ALERT SERVICE BULLETIN

Service Bulletin No.: DA20-55-02-A, Rev. 0

Title: Mount, Forward Attachment, Horizontal Stabilizer

Figure 1. Horizontal Stabilizer Forward Mount Attachment (Ref. Detail A).

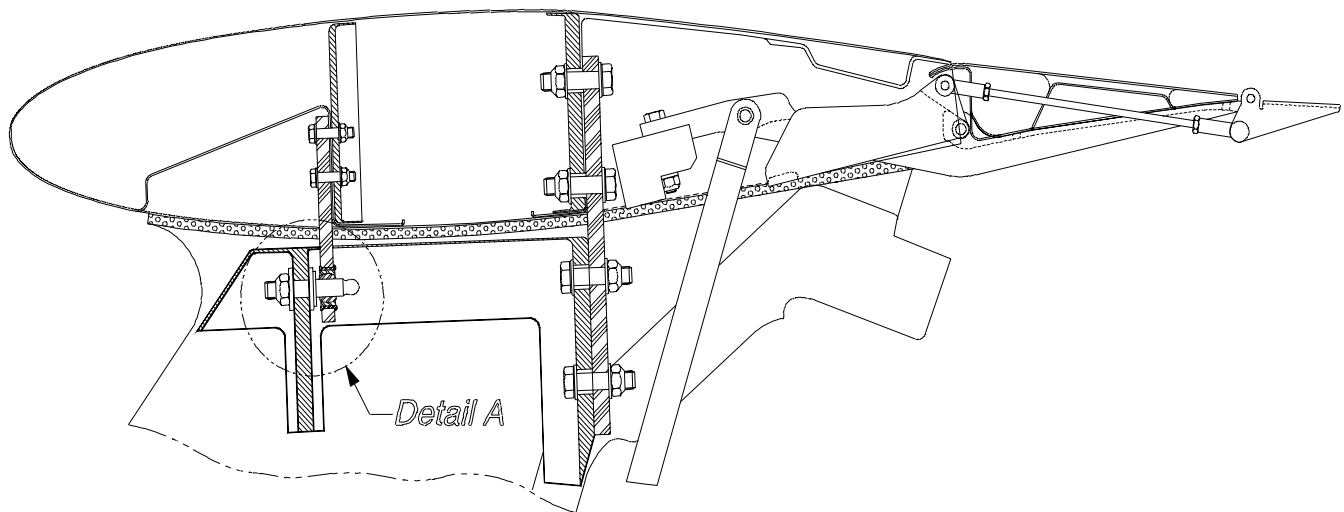
- 10.1 Deflect rudder to either left or right stop and hold.
- 10.2 Use a flashlight and inspection mirror to inspect the forward stabilizer mount assembly through the rudder balance cut out in the vertical stabilizer for the presence of the retaining ring (ref. DA20 Parts Catalog, attached figures 1 and 2).
Note: The retaining ring may be partially painted and difficult to distinguish from the mount plate. Positively ensure proper location of the retaining ring by identifying the snap ring plier holes.

Figure 3. Detail A - Incorrect Retaining Ring Installation.

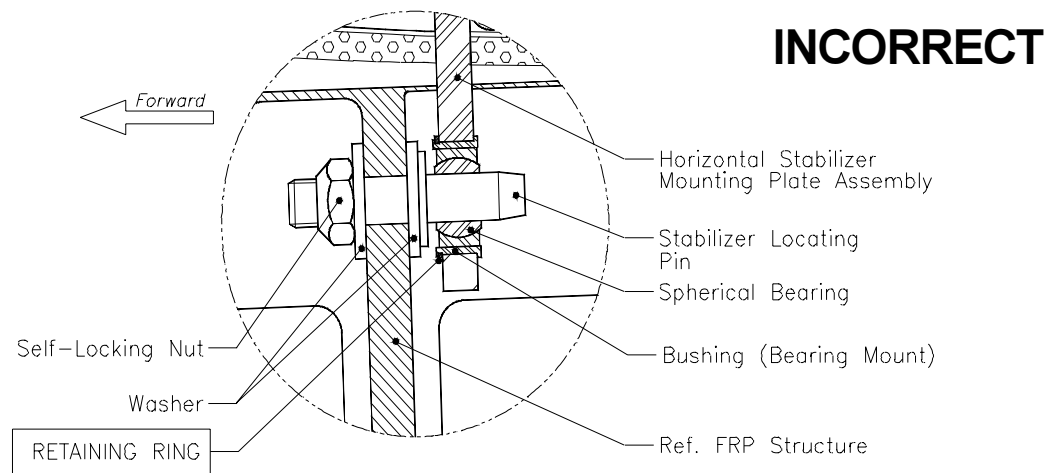
- 10.3 If stabilizer mount is assembled correctly, no further action is required.
- 10.4 If stabilizer mount is assembled incorrectly (as shown on figure 3), remove horizontal stabilizer in accordance with the Maintenance Manual, remove snap ring, remove bushing and reassemble in correct sequence.
Note: Do Not remove mount plate from stabilizer as it is bonded in place.
